Form C-103
Revised July 18, 2013

Chevron USA INC respectfully request to abandon this well as follows:

*** SEE ATTACHED COA'S - Revised

SOUTH CULEBRA BLUFF UNIT 3
Loving East - 30-015-22700
Eddy County, New Mexico
G-23-23S-28E 2050 FNL 1950 FEL

SOUTH CULEBRA BLUFF UNIT 3
Loving East - 30-015-22700
Eddy County, New Mexico
G-23-23S-28E 2050 FNL 1950 FEL

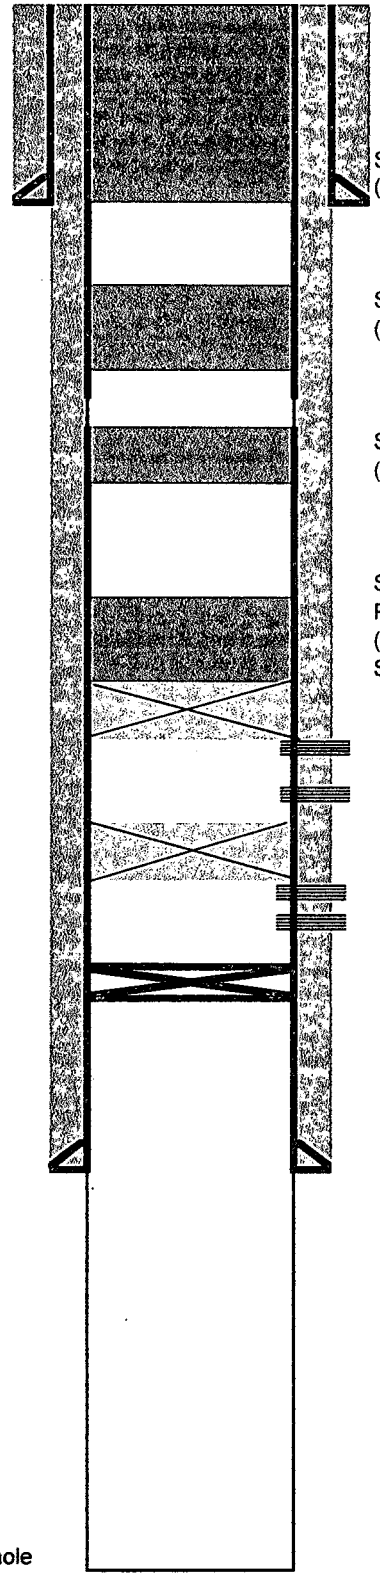
1.Call and notify NMOCD 24 hrs before operations begin.
2. Move in rig and rig up all CMT equipment
3. RIH and set CIBP @ 6180'
4. RIH and set CIBP @ 5739' Pressure test @ 1000 psi for 10 minutes WOC & Tag
5. Spot 270 sx CL "C" cmt f/ 5739't/ 4614', ~~do not~~ WOC & tag if casing passed a pressure test (perfs, Brushy Canyon)
6. Spot 40 sx of Class C CMT f/ 3503' to 3334'. (Cherry Canton)
7. Spot 100 sx of Class C CMT f/ 2690' t/ 2272 ' (BSalt, Lamar LS, Bell Canyon).
8. Spot 130 sx f/ 535't/ Surface (Shoe, T-Salt, WB).
9.Cut all casings & anchors & remove 3' below grade. Verify cement to surface & weld on dry hole marker as per, NMOCDrequirements. Clean location.

MUST BE PLUGGED BY
1/8/21

Spot 130 sx of Class C CMT f/ 535' to Surface
(T Salt, Shoe WB)

Spot 100 sx of Class C CMT f/ 2690' to 2272'
(B Salt, Lamar LS, Bell Canyon)

Spot 40 sx of Class C CMT f/ 3503' to 3334'
(Cherry Canyon)

Spot 270 sx of Class C CMT f/ 5739' to 4614'
Pressure Test @ 1000 psi for 10 minutes
(Brushy Canyon)
Set CIBP @ 5739'

Brushy Canyon "C" frac'd in '06
6128'- 6170' - 4 spf
Note: No NMOCD Record; Per Range's Record
Set CIBP @ 6180'
